Service Bulletin

RCL-05-003

Subject: Update: ST Airbox Breather Hose Modification

Models: Ducati Motorcycles: ST3 - ST4S - ST4S ABS MY 2004

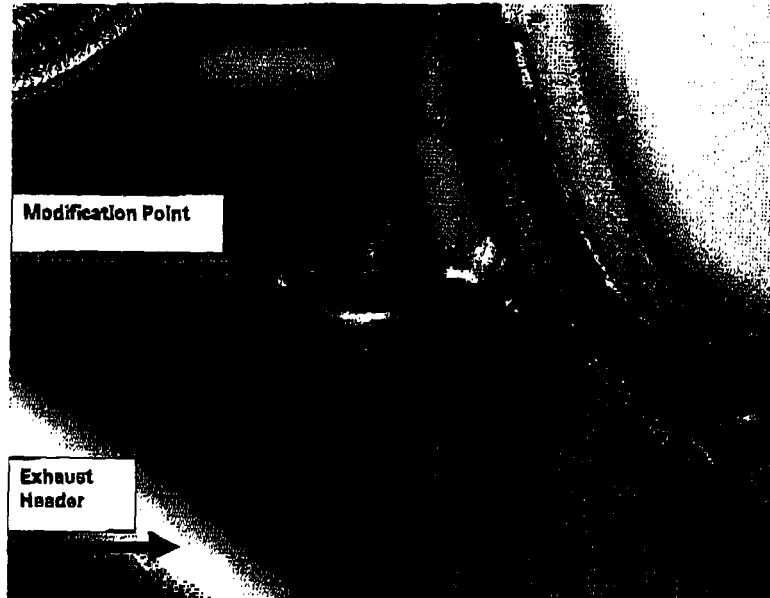
Ducati Motor S.P.A. has determined that it is possible that the air box breather hose may become in contact with the horizontal cylinder exhaust pipe creating a potential

fire hazard.

Remove the right side fairing. Release the air box breather hose from the retaining clip secured to the engine side cover. Remove hose from the rubber plug end and cut off approximately five inches of the rubber hose (PN 87720042A). Re-install shorten air box breather hose to the mounting rubber plug (a touch of super-glue should be used) and secure it to the engine side cover using original mounting clip. Make sure air box breather hose end is at the same level of the mounting clip and it is far away from the horizontal cylinder exhaust pipe. See picture below.
